SUBJECT: Forwards proposed changes to FSAR Sections 1.9, 2.4, 6.3, 1.4, 15.1.5 & app 15C incorporating results of main steam line break analyses. Changes will be incorporated into next FSAR amend per NRC approval.

Subject: Palo Verde Nuclear Generating Station (PVNGS)  
Units 1, 2, and 3  
Docket Nos. STN 50-528(License No. NPF-41)/529/530  
Main Steam Line Break Analyses Results - Chapter 15 Reanalyses  
File: 85-056-026; G.1.01.10

The results are presented as proposed changes to FSAR Sections 1.9.2.4, 6.3.1.4, 15.1.5 and Appendix 15C and are all within NRC acceptance criteria. Upon NRC approval, these FSAR changes will be incorporated into the next PVNGS FSAR Amendment.

FULL POWER LARGE STEAM LINE BREAK WITH  
CONCURRENT LOSS OF OFFSITE POWER  
FEEDWATER ENTHALPY VS TIME  
Figure 15.1.1-12

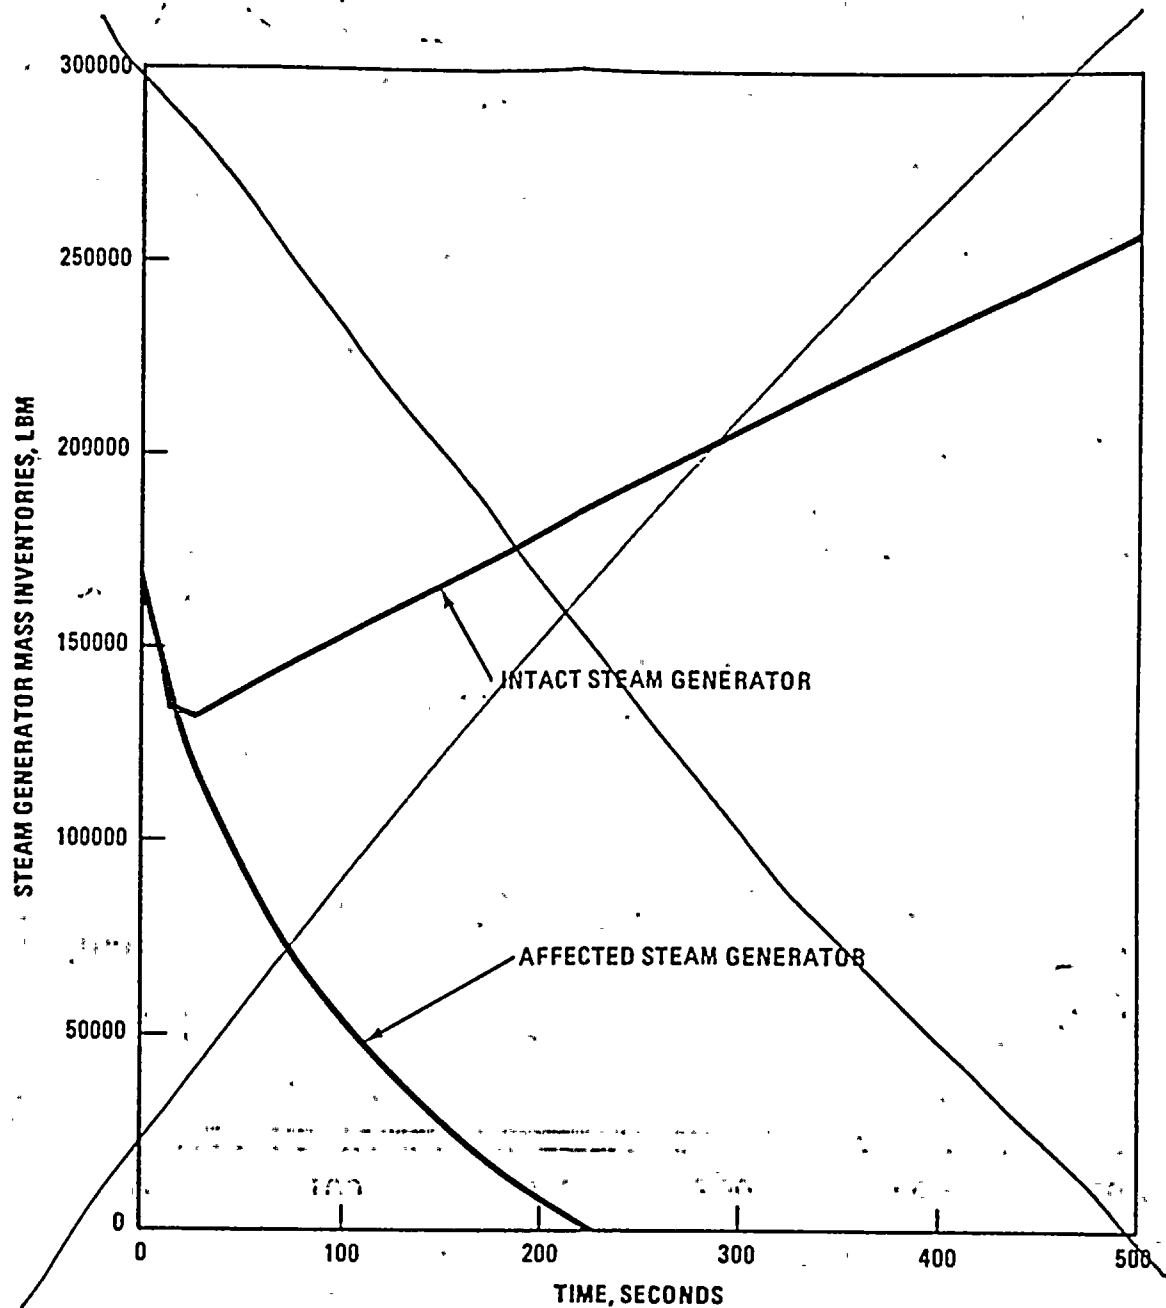
Replace with Figure 15.1.1-13

Figure 15.1.1-13

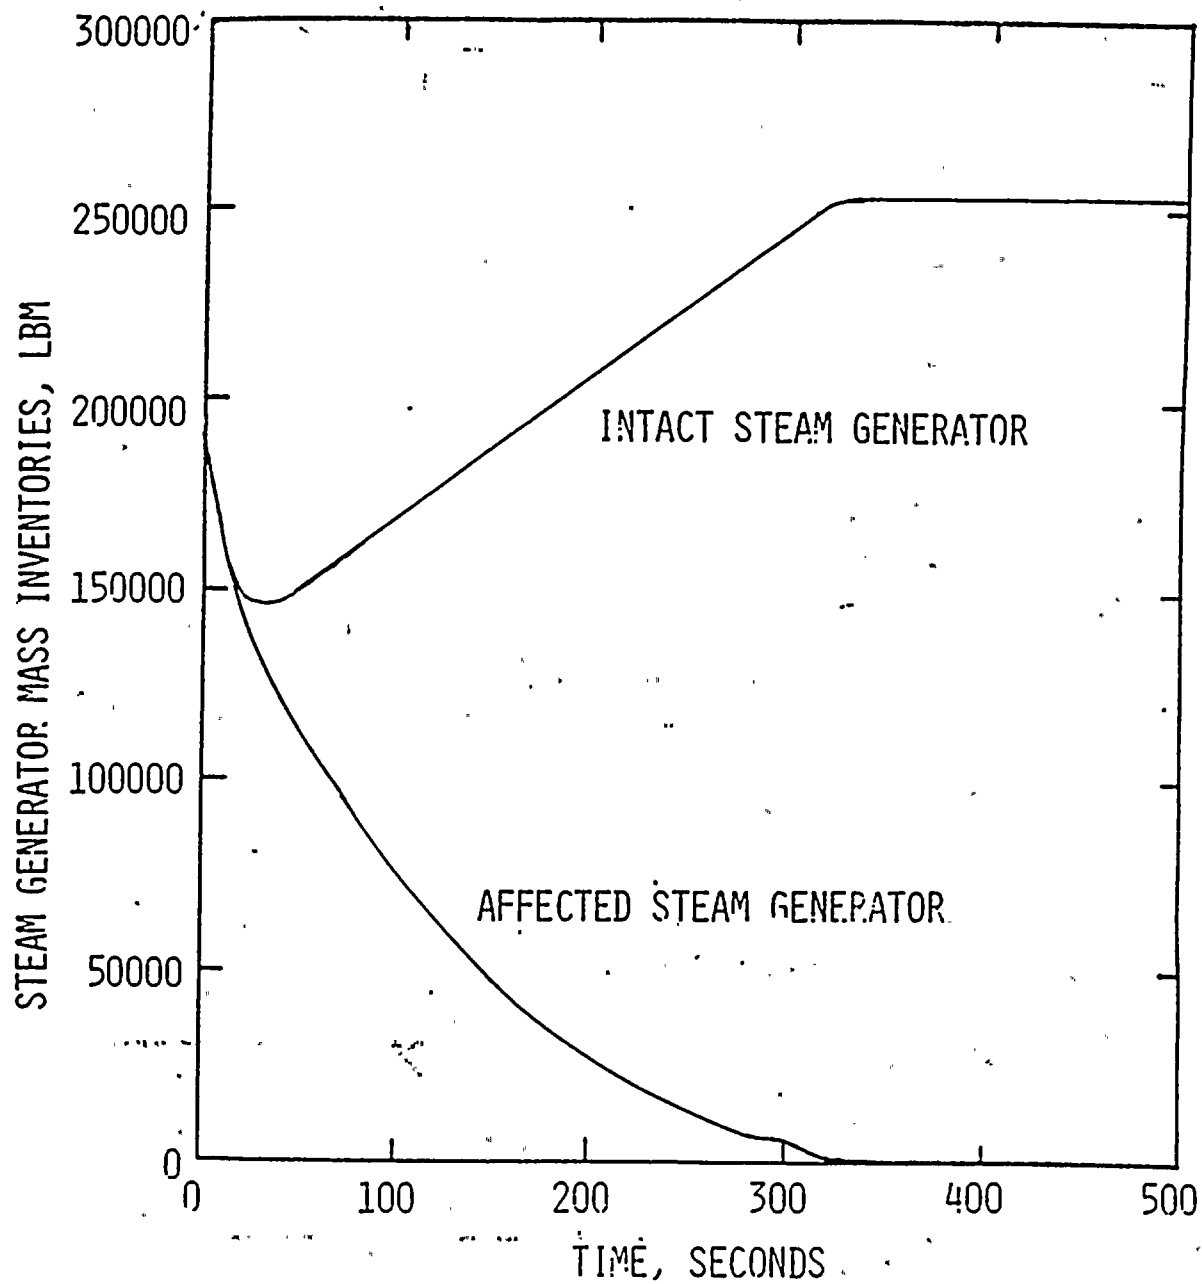
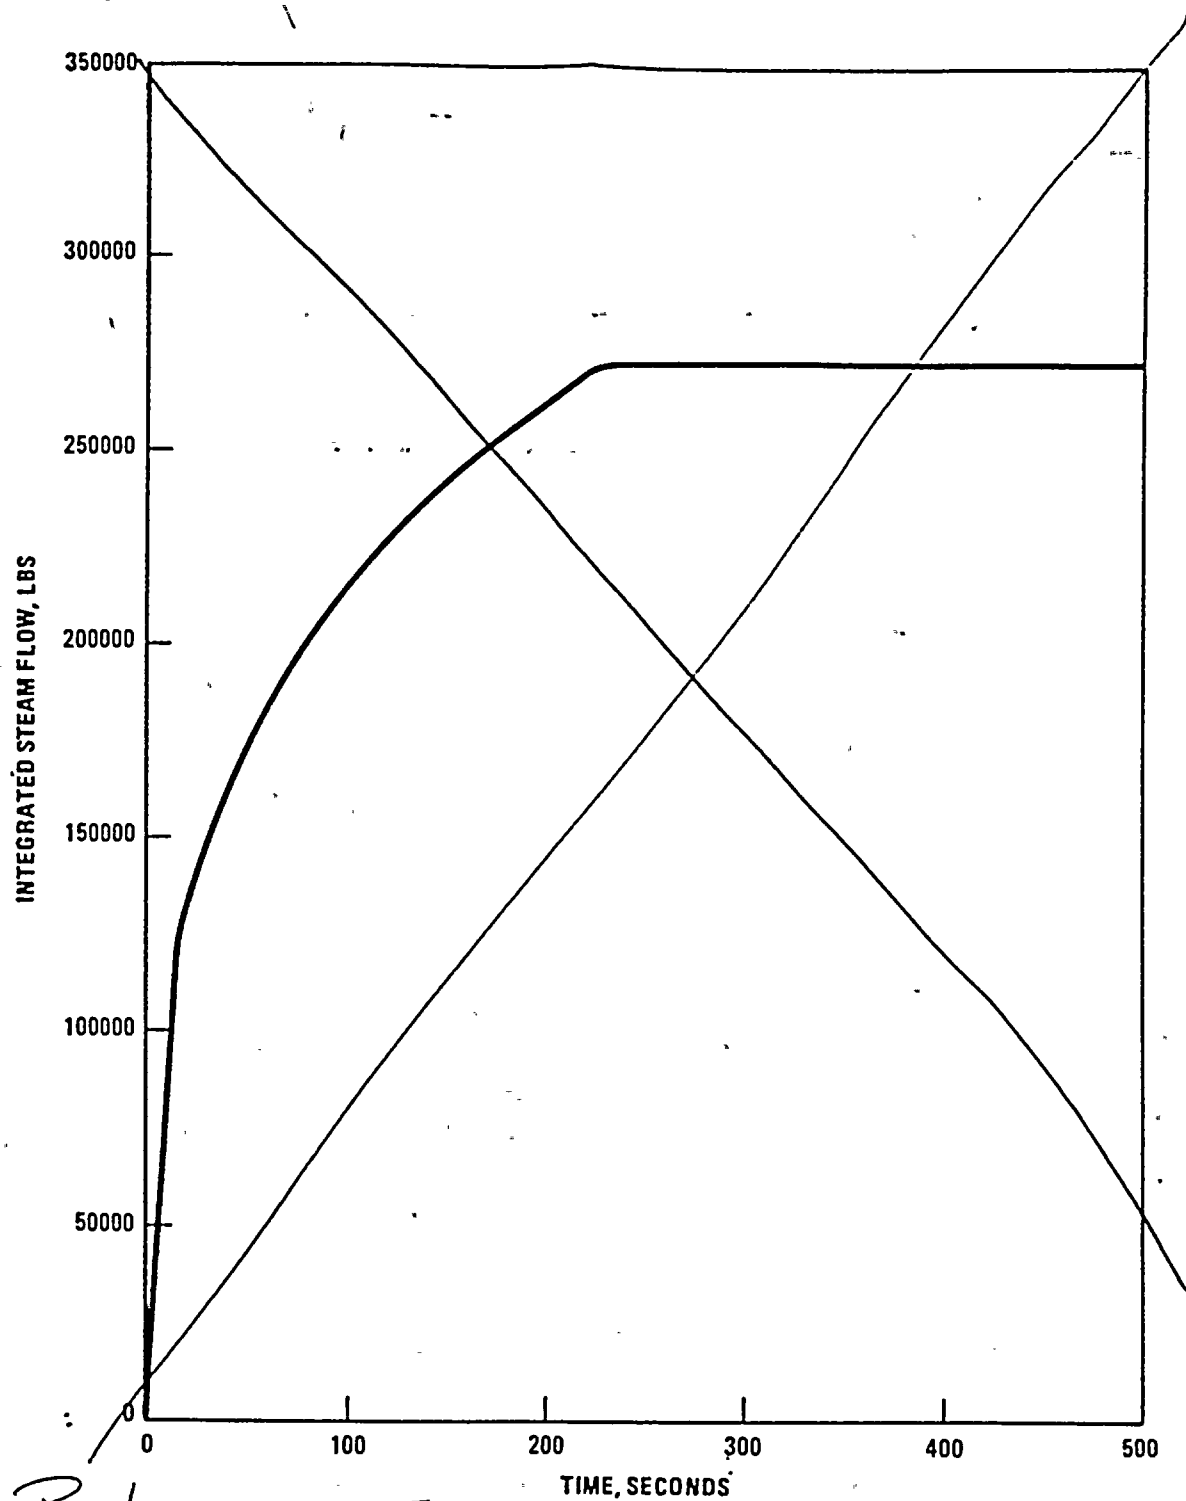
Replace with Figure 15.1.1-14

Figure 15.1.1-14

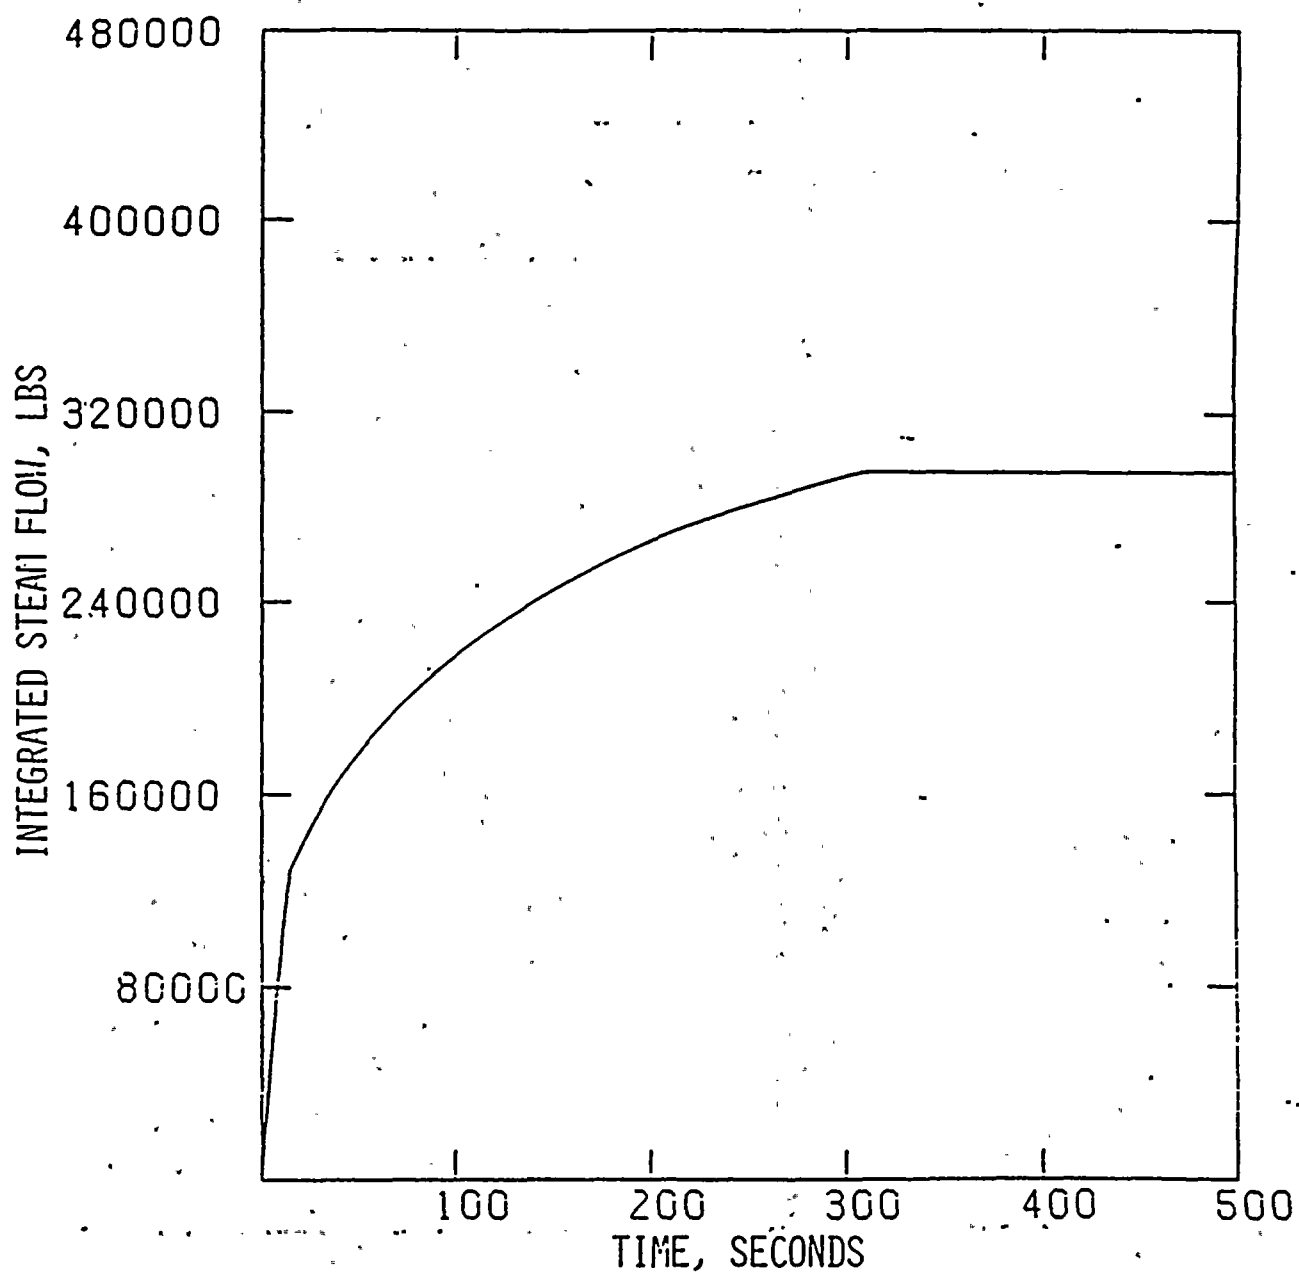
Replace with Figure 15.1.1-15

Figure 15.1.1-15

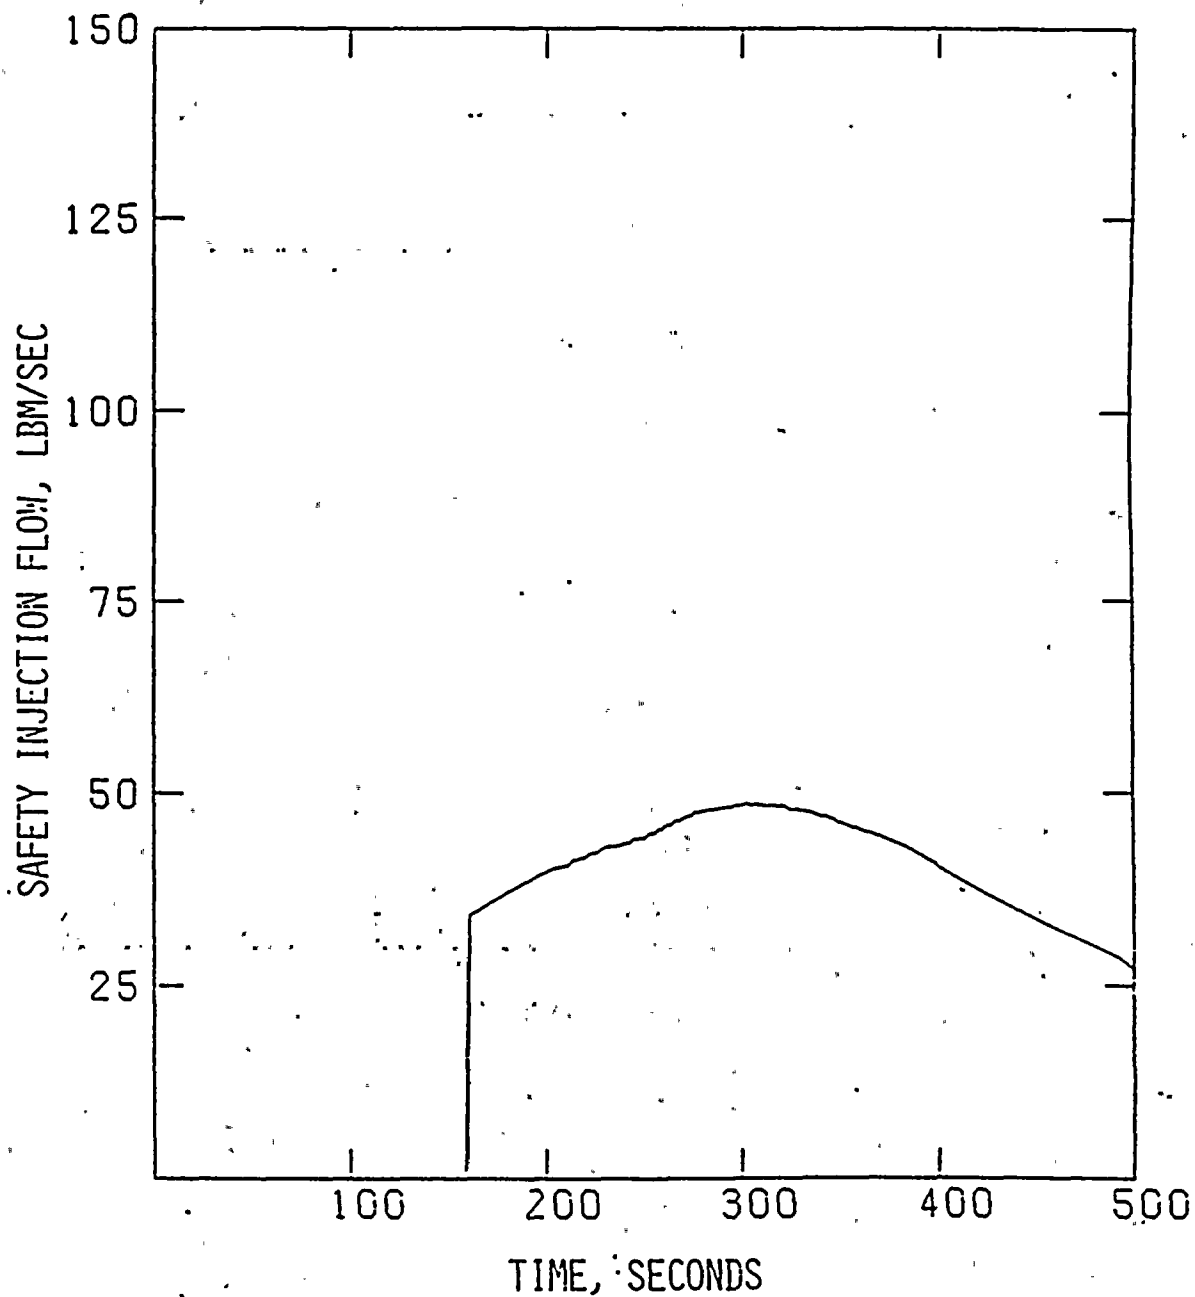
Replace with Figure 15.1.1-16

FULL POWER LARGE STEAM LINE BREAK WITH  
CONCURRENT LOSS OF OFFSITE POWER  
REACTOR VESSEL LIQUID VOLUME VS TIME  
Figure 15.1.1-16.

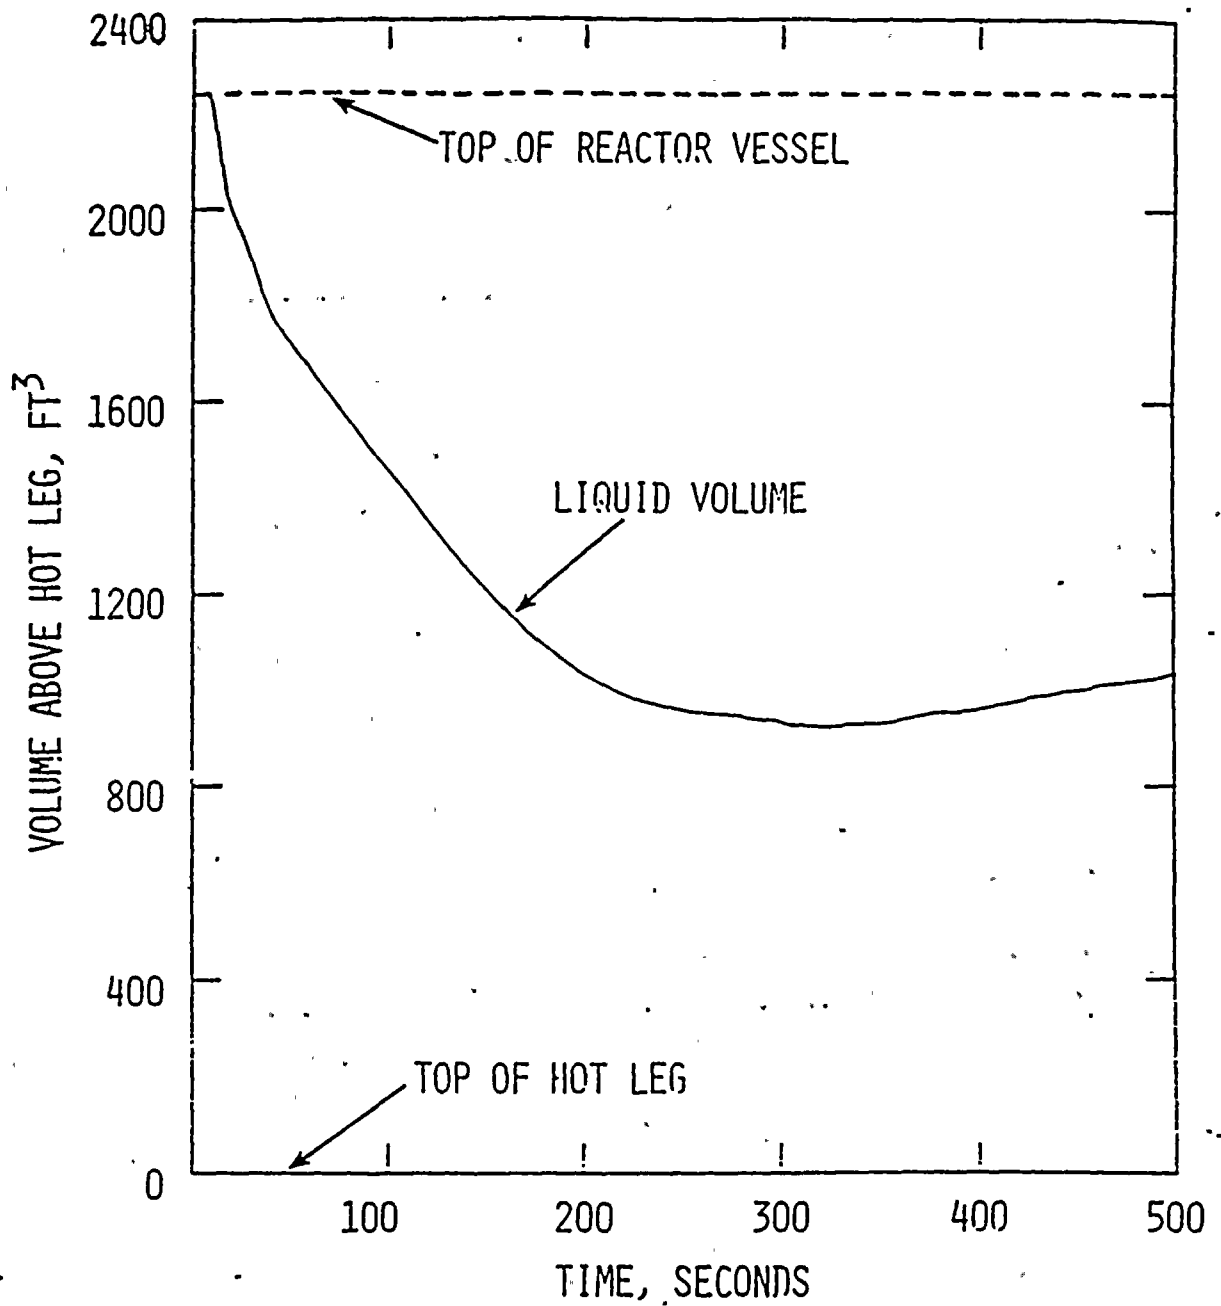
Replace with figure 15.1.1-17
